Recall Bulletin

SB-10056213-2052

PRODUCT EMISSION RECALL

SUBJECT: Oxygen Sensor Fracture

First and Second Design Sensors

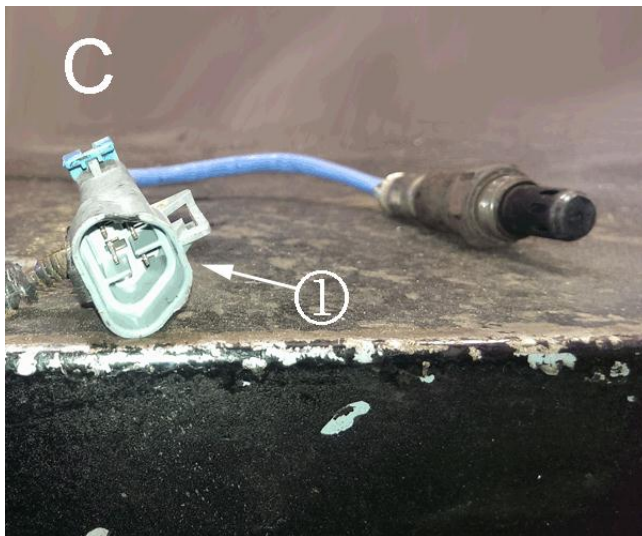
(A) 2011 through early 2013 OE production first design male connector. Replace the part with a second design part with a male connector, P/N 12637297. (B) 2011 through 2013 second design service part, P/N12637297. Do NOT replace this part unless the part has failed. If the part has failed, replace the part with the second design part with a male connector, P/N 12637297.

(C) This is the second design 2013 production sensor with the female plug (1). The sensor and plug change was made to indicate the new design. Do NOT replace this sensor, P/N12656071, unless the part has failed.

3. Determine if a first design (A) or second design (B) heated oxygen sensor is installed using a light and mirror.
 - If a second design (B), P/N 12637297, P/N 12656071 heated oxygen sensor is currently installed, no further action is required. Lower the vehicle. Refer to *Lifting and Jacking the Vehicle* in SI.
 - If a first design (A), P/N 12612571, heated oxygen sensor is in place, remove the sensor and replace it with a second design heated oxygen sensor. Refer to *Heated Oxygen Sensor Replacement –Bank 2 Sensor 2* in SI and *Heated Oxygen Sensor Replacement –Bank 1 Sensor 2* in SI.
